AGENDA
CONCEPTUAL PLAN REVIEW COMMITTEE
Community Room, 3rd Floor
Arlington Heights Village Hall, 33 S. Arlington Heights Rd.
Arlington Heights IL 60005
February 11, 2026
6:00 PM

To: Conceptual Plan Review Committee
Prepared By: Darko Bojin, Planner I
Meeting Date: February 11, 2026
Date Prepared: January 29, 2026

Item: AH Park District Centennial Park - 1301 E. Burr Oak Dr. - T1898
Comprehensive Plan Amendment, Planned Unit Development, Rezone, Special Use Permit with Variations
Department: Planning & Community Development

To: Conceptual Plan Review Committee
Prepared By: Dan Osoba, Planner II
Meeting Date: February 11, 2026
Date Prepared: January 29, 2026

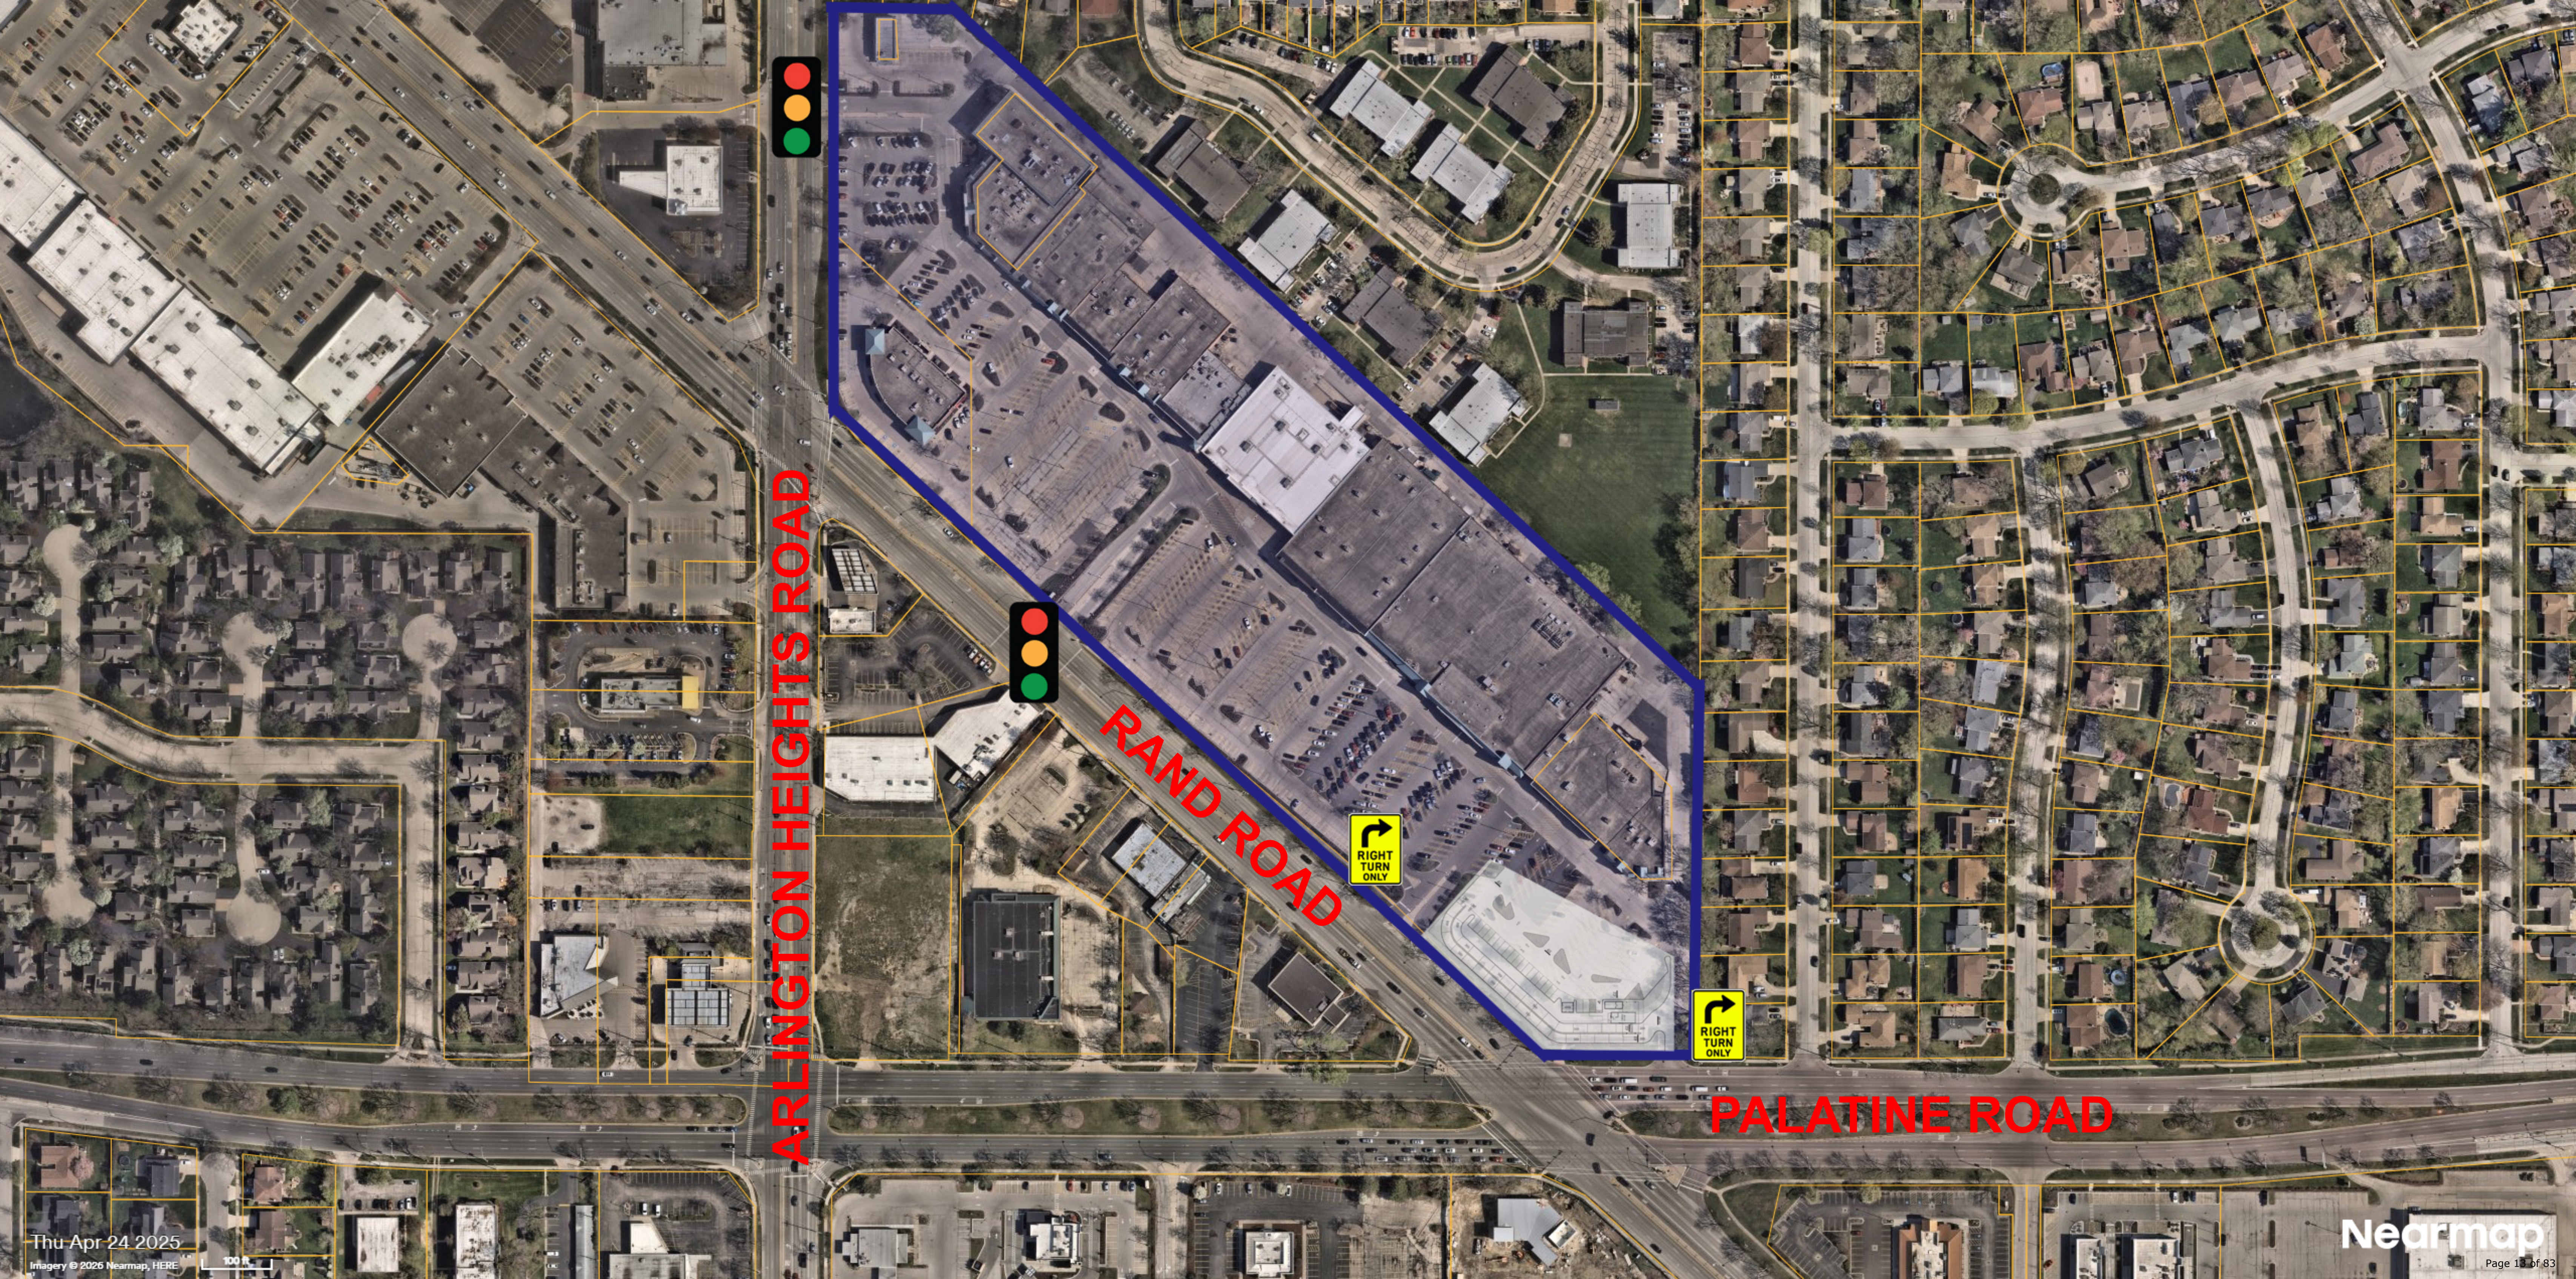
As was provided in the Project Background, the two closest access points to the proposed use from E. Rand Road and E. Palatine Road function as right-in, right-out driveways with no signalization. Access to the proposed drive-through lanes is provided by the common roadway through the shopping center and one of the parking lot drive lanes. Staff has significant concerns regarding the potential for the drive-through queue and the volume of patrons impacting the parking aisles, main shopping center drive, and the access points on E. Rand Road and E. Palatine Road. The petitioner will be required to illustrate, in detail, potential impacts of the drive-through operations including data from existing sites that operate with a similar configuration to include in the traffic study and parking analysis. The analysis should illustrate the potential impacts on the main access points, main shopping center drive, and parking lot access, how a bypass lane may be incorporated, and peak hour traffic impacts. In addition, the study should also investigate the reconfiguration of the proposed one-way exit driveway on E. Palatine Road on the entire shopping center operation and how the headlights from patrons may impact the residential development to the east when exiting the drive-through.

This new use will increase bicycle parking requirements in the PUD by 2 spaces. A bicycle parking survey will be required to determine whether or not there is sufficient existing bicycle parking in the PUD or if additional spaces need to be provided:
